## Forward Planning Policy Comment

### Edenfield Masterplan and Design Code

This response relates to the revised Masterplan and Design Code (submitted June 2023). It is not intended to refer specifically to Taylor Wimpey's related planning application.

Figure 1- Proposed character areas by Randall Thorp for Taylor Wimpey (left) and draft character areas identified by AECOM for ECNF (right)

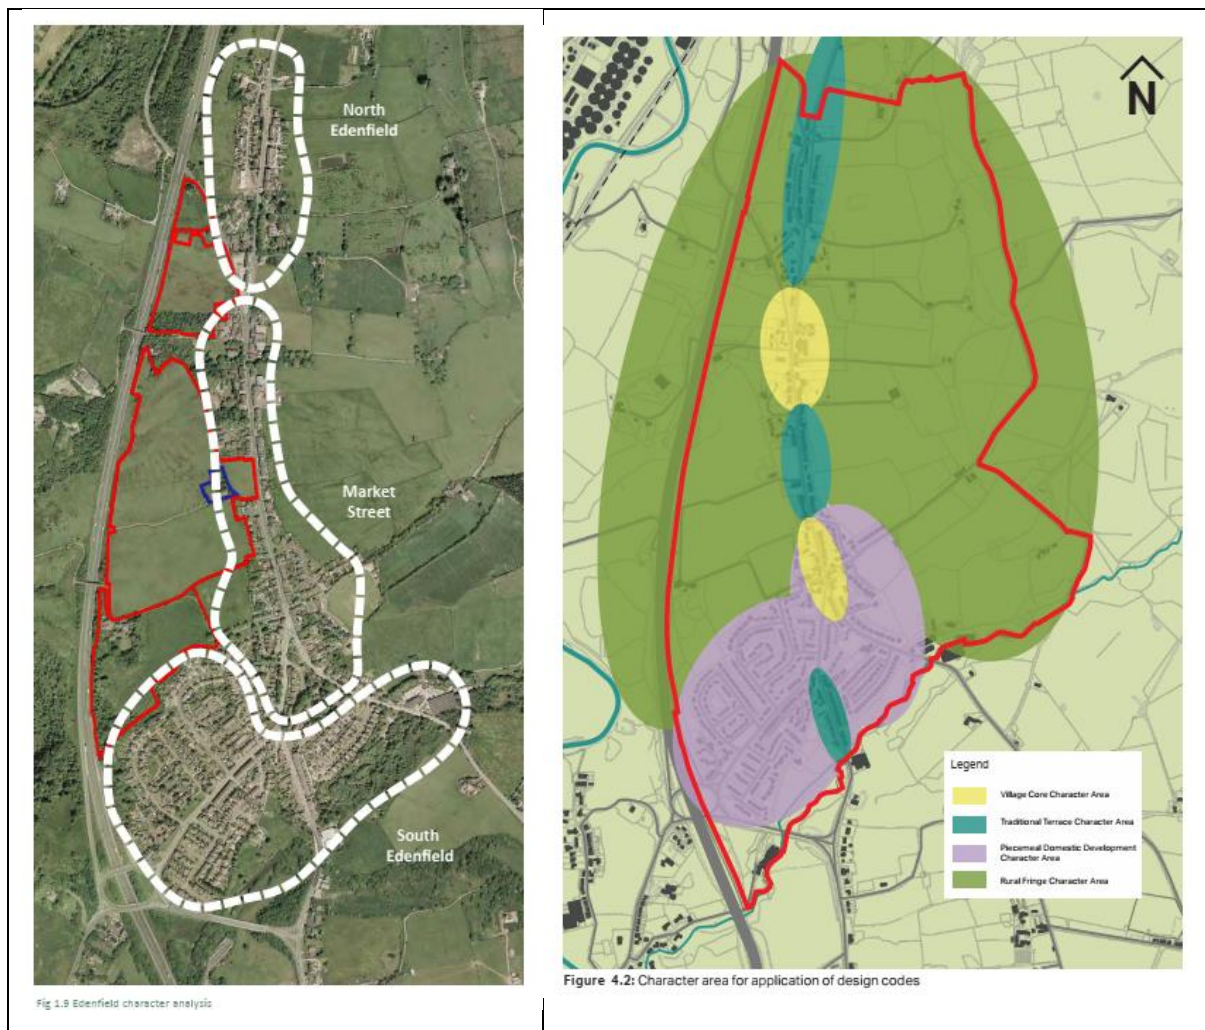
The Masterplan and Design Code identifies three character areas for the existing Edenfield settlement: north Edenfield, Market Street and South Edenfield. The identification of these character areas is slightly different from the ones proposed in

the draft Design Code of the Neighbourhood Plan where four character areas for the Neighbourhood Area have been identified. These are: the village cores, the traditional terraces, the piecemeal domestic development mainly in south Edenfield and the rural fringe. This is shown on the diagram below:

The Masterplan explains the differences between these in much more detail, justifying these Character Areas.
